SOUTHERN UTAH WILDERNESS ALLIANCE	)	<b>IBLA No. 2018-0107</b>
and GRAND CANYON TRUST,	)	
	)	Appeal of the Monticello Field
Appellants,	)	Office's Decision Record and Finding
	)	of No Significant Impact for the
v.	)	Daneros Mine Plan of Operations
	)	Modification, DOI-BLM-UT-Y020-
U.S. BUREAU OF LAND MANAGEMENT,	)	2016-0001-EA (Feb. 2018)
	)	
Respondent,	)	
	)	
ENERGY FUELS RESOURCES (USA), INC. and	)	
EFR WHITE CANYON CORP.,	)	
	)	
Intervenor-Respondent.	)

**APPELLANTS' STATEMENT OF REASONS**

*Id.* at PDF p. 2.

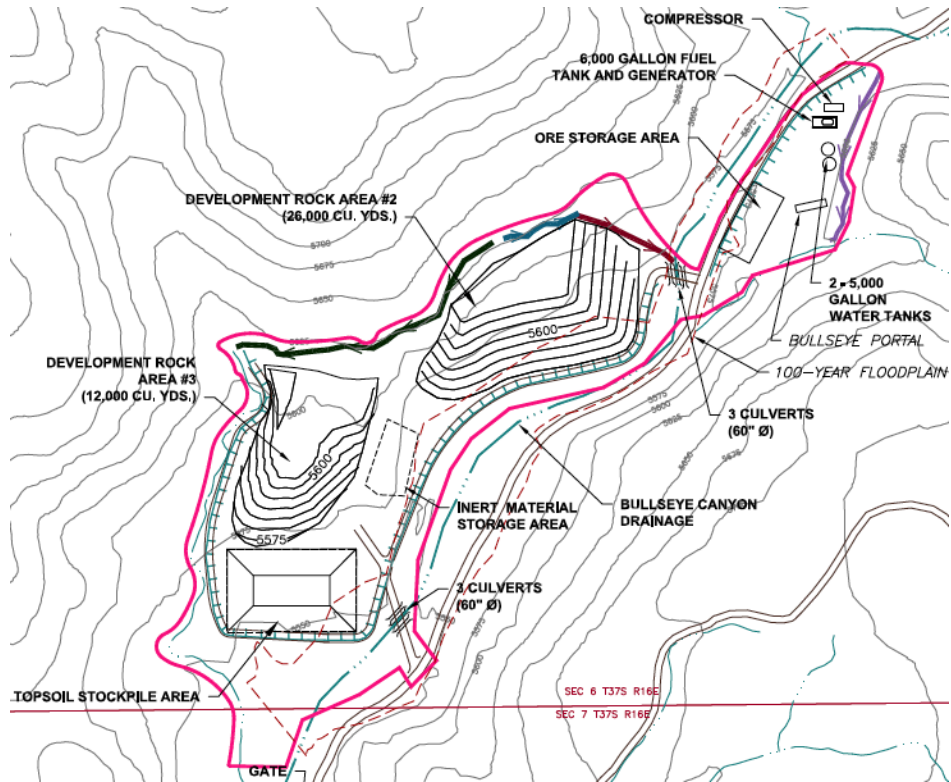
Both the EA and MPOM unmistakably show that the Bullseye Portal area’s upper DRA (“DRA #2”) and ore storage area are sited *within* the 100-year floodplain. Side-by-side comparison of the MPOM’s 100-year floodplain illustration (MPOM, AR 2016.11.03.02, Att. R, Fig. 3, PDF p. 1104) to Figure 4 in the EA, which depicts DRA #2 and the ore-storage area (AR 2018.02.23.01, PDF p. 141), reveals that portions of DRA #2 and the ore storage area are sited within the floodplain. *See also* MPOM Figure 3-2b, AR 2015.11.03.02, PDF p. 1238. And a May 25, 2016 email from Energy Fuels to BLM removes all doubt: “As you can see, we will need to modify the design of the upper development rock storage area proposed at the Bullseye Portal in order to locate it entirely out of the flood plain. AR 2016.05.25.05, PDF p. 1. In fact, examination of the May 25, 2016 email’s attached Figure 8 map demonstrates that portions of DRA #2 *and* the ore storage area are sited within the 100-year flood plain, represented on that map as the red dashed line:

There is accordingly no rational basis for BLM’s conclusion that the MPOM will avoid unnecessary and undue degradation by siting the Mine’s facilities above the 100-year floodplain. Siting the ore stockpile area and DRA #2—both of which contain hazardous materials—partially within the 100-year floodplain violates section 3809.420(b)(2)’s requirement that all tailings and deleterious materials or substances “shall be disposed of so as to prevent unnecessary or undue degradation,” and section 3809.420(b)(11)’s requirement to place potentially acid-forming, toxic, or other deleterious materials to “minimize” the “impacts” and “uncontrolled migration” of “acidic, alkaline, metal-bearing, or other deleterious leachate.”<sup>3</sup> 43 C.F.R. §§ 3809.420(b)(2),
